Work Order ID 134602

DART SERVICE INSTRUCTION

TO AMEND INSTALLATION INSTRUCTIONS D350-607-3 Rev.D,
INSTALLATION INSTRUCTIONS D350-607-4 Rev. C AND
INSTRUCTIONS FOR CONTINUED AIRWORTHINESS ICA-D350-607 REV. 6

REF TCCA STC: SH94-14
REF FAA STC: SR00213NY
REF EASA STC: EASA.10016996
REF BRAZILIAN STC: 2007S03-03/-04/-05/-06

FIGURE 1: INSTALLATION OF D4775-041 FWD STRUT

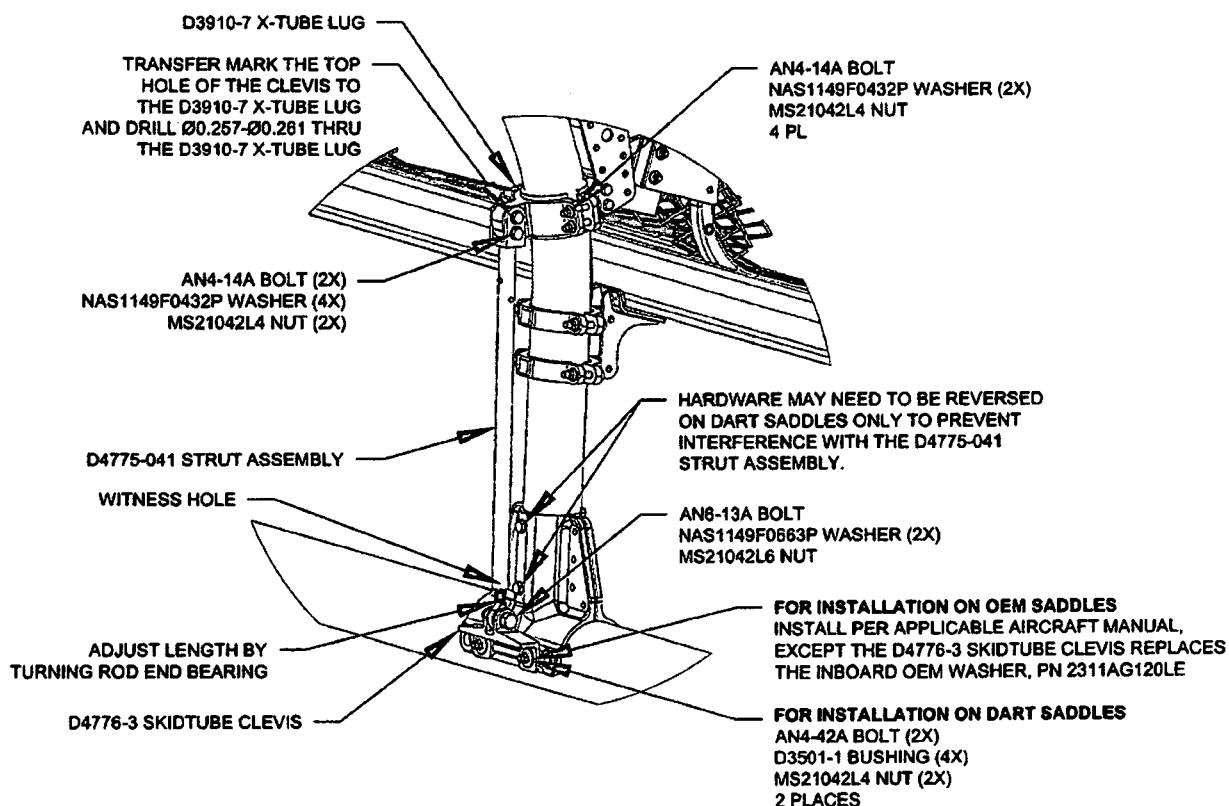
3.1 Substitute the Forward Lower D3910-5 X-Tube Lug with the D3910-7 X-Tube Lug as shown in Figure 1.

3.2 Install the forward D4775-041 Strut Assembly. Transfer mark from the upper hole on the clevis of the D4775-041 Strut Assembly to the D3910-7 X-tube Lug and drill thru the lug $\varnothing 0.257$ - $\varnothing 0.261$ as shown in Figure 1. Touch up chemical conversion coating per MIL-DTL-5541. Check the witness holes located at the bottom end of the D4775-041 Strut Assemblies to ensure that the thread from the rod end extends past the witness hole.
Torque MS21042L4/-4 nuts to 50-70 in-lbs (5.7-7.9 N-m). Torque MS21042L6/-6 nuts to 160-190 in-lbs (18.1-21.5 N-m).
